Subject: Dakota Electric Association Comments

In the Matter of Impacts of the “Capacity” Definition in Minnesota Statute 216B.164 and Associated Rules on Net Metering Eligibility for Rate-Regulated Utilities

Docket Nos. E-002, -111, -017, -015/CI-24-200 and E999/R-25-86

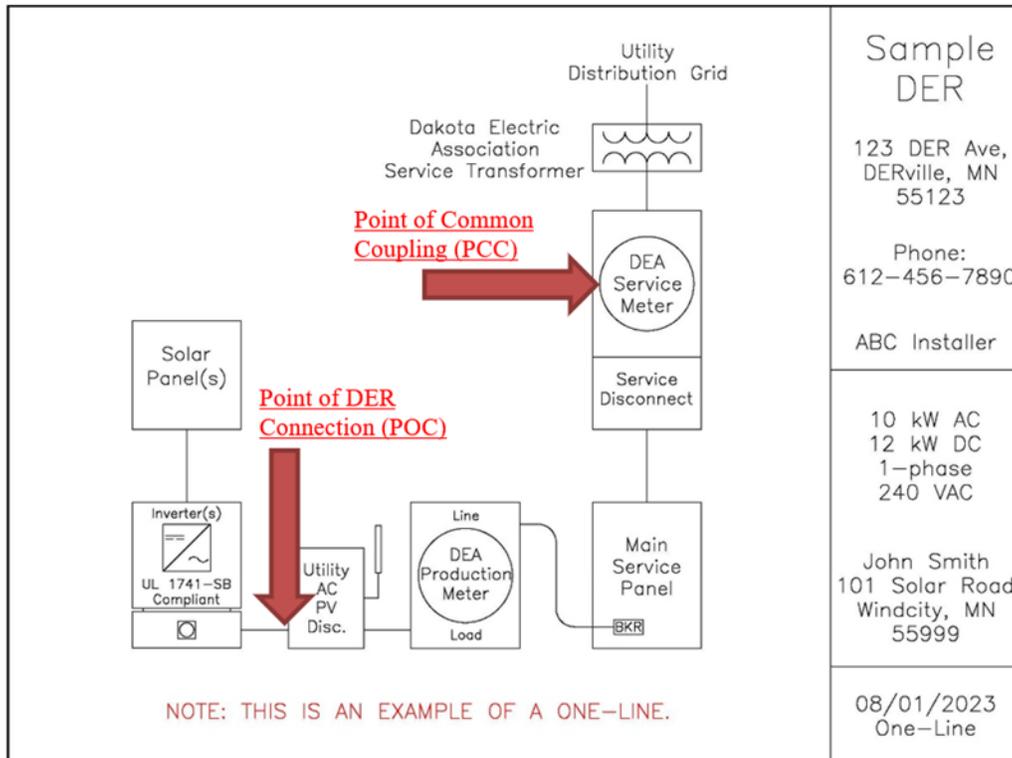
Most importantly on this topic, Minn. Stat. § 216B.164 does not refer to the amount “exported” to the grid as the capacity of the facility or uses the term “point of common coupling.”²⁶ The term “point of common coupling” that is currently in Minnesota Rule 7835.0100 was a significant complicating factor in the previous dockets, as the definition contained in Minnesota Rules does not align with MnSEIA’s proposed interpretation or common industry usage, as discussed in more detail below.

In Docket No. 24-200, several utilities, including Dakota Electric, provided pictorial diagrams denoting the difference between the point of common coupling and the point of interconnection.²⁷ The Cooperative provides a sample one-line diagram from our TSM to illustrate the difference between the two points.
